# 15 SUB2009-00168

## **HERRINGTON'S SUBDIVISION**

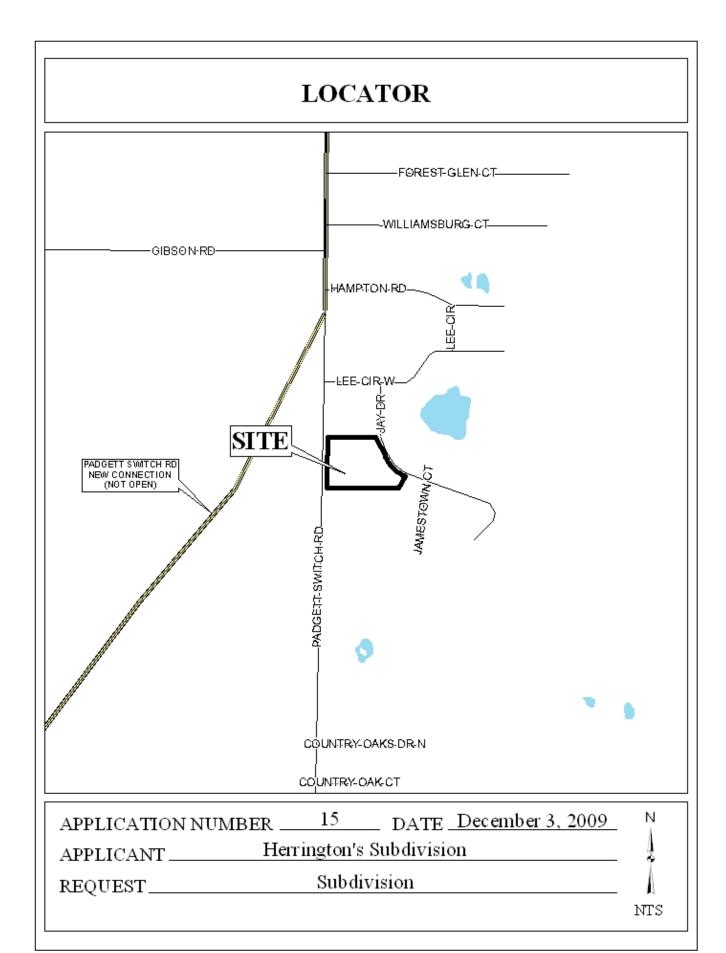
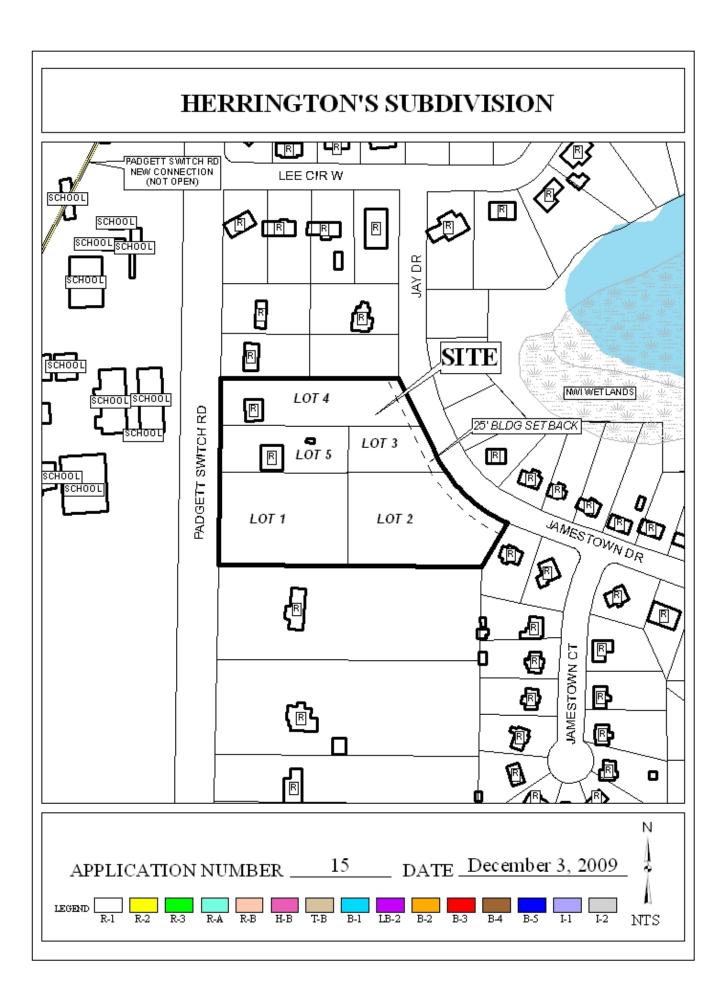
It should further be noted that the legal description of the subdivision does not include the proposed Lot 5, and, as such, the legal description on the plat should be revised to include that portion of the site.

The sizes of the proposed lots are not shown on the preliminary plat; however, all appear to meet the minimum size requirements as regulated by Section V.D.2 of the Subdivision Regulations. As the lot sizes are not indicated, the plat should be revised to indicate the lot size, in square feet, or a table provided on the plat showing the same information.

The proposed Lot 4 is depicted with access to both Padgett Switch Road and Jamestown Drive. Double frontage lots generally do not comply with Section V.D.8 of the Subdivision Regulations. However, in order to maintain the character of the existing subdivision, a waiver of this section may be appropriate. If a waiver is approved, then access to Jamestown Drive should be denied due to the site already accessing Padgett Switch Road.

The existing curb cuts to site are depicted on the preliminary plat. The proposed Lot 4 is depicted with two existing curb cuts to Padgett Switch Road, and the proposed Lot 5 is depicted with one curb cut to Padgett Switch Road. No other existing curb cuts (if any) to any other road are depicted. The proposed Lot 1, with 214 feet of frontage along Padgett Switch Road should be limited to two curb cuts to the same. The proposed Lot 3 should be limited to one curb cut to Jamestown Drive, and the proposed Lot 2 should also be limited to one curb cut to Jamestown Drive. The size, design, and location of all curb cuts should be approved by Mobile County Engineering and conform to AASHTO standards.

The 25-foot minimum building line is depicted on all lots and right-of-way except on the proposed Lot 5. The final plat, if approved, should be revised to depict the 25-foot building setback line along Padgett Switch Road on the proposed Lot 5.

Based on the preceding, this application is recommended for holdover until the January 7, 2010 meeting, with revisions due by Wednesday, December 16, 2009 to address the following:

- 1) Submittal of authorization from the property owner for inclusion of the proposed Lot 5 (West 290 feet of Lot 1, Resubdivision of Lot 22 Jamestown Estates First Addition MB 67 MP 54); and
- 2) Submittal of a new preliminary plat showing the revised Legal Description which incorporates the proposed Lot 5 area;
